Informal meeting on Code of Practice for Packing of Cargo Transport Units

Geneva and virtual, 12-13 July 2022

Bedding arrangements

Submitted by IUMI and Mariterm AB

Figure 7.21 Load transfer beams

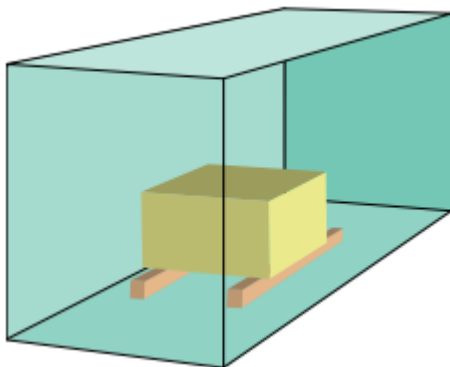
3.1.1 Freight containers, ~~flatracks and platforms~~ are designed according to ISO standards, amongst others, in such a way that the permissible payload P, if homogeneously distributed over the entire loading floor, can safely be transferred to the four corner posts under all conditions of carriage. This includes a safety margin for temporary weight increase due to vertical accelerations during a sea passage. When the payload is not homogeneously distributed over the loading floor, the limitations for concentrated loads should be considered. It may be necessary to transfer the weight to the corner posts by supporting the cargo on strong timber or steel beams as appropriate (see figure 7.21).

3.1.2. The necessary length (L_R) of these beams depends on the cargo **weight mass** and their mutual distance (B). It is important to make the distance B of the longitudinal beams as large as possible in order to minimise the stress onto the cross-members of the container floor.

The beams must have sufficient strength for effectively spreading the load. Their necessary dimensions should be determined by the cargo **weight mass** and the intended spreading effect, expressed by their “free length”.

This simple arrangement complies with the principles of structural engineering. There is no benefit of flooring the area under the cargo item with beams of lesser strength.

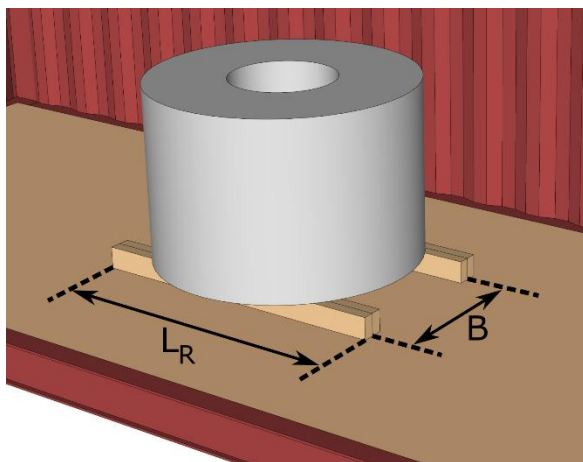
3.1.2.1 - Step 1 - Minimum length

The bedding beams must be long enough to cover the distance of the container’s floor so that load from the cargo will not overstress the floor.

The minimum length depends on the following factors:

- The cargo mass (in **tonnes**)
- The spacing of the beams, B (in meters)

Table X.1 below gives the minimum required length, L_R , of longitudinal bedding beams based on these two factors.

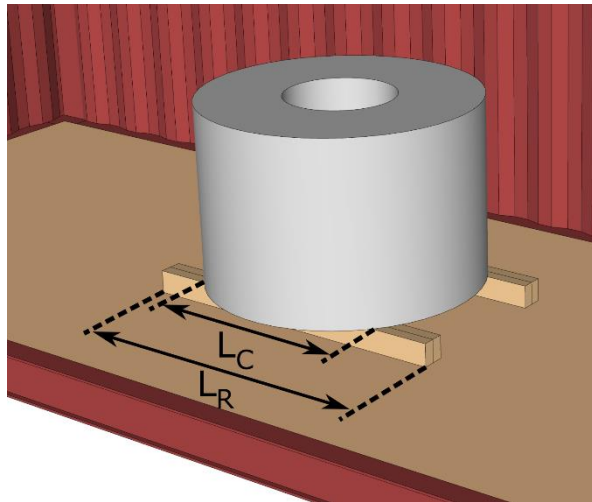
3.1.2.2 Step 2 - Minimum dimensions

The proper size of the bedding beams depends on the bending resistance (section modulus) that is required of the beams for them to successfully transfer the load from the cargo over the required floor length. The required section modulus depends on the following factors:

- The cargo mass (in tonnes)
- The minimum length of the beams, L_R (in meters), as given by Table X.1
- The length of the footprint of the cargo on the beams, L_C (in meters)
- The strength of the material of the bending beams

The difference between the length of the beams, L_R , and the length of the cargo footprint, L_C , is denominated as the free length.
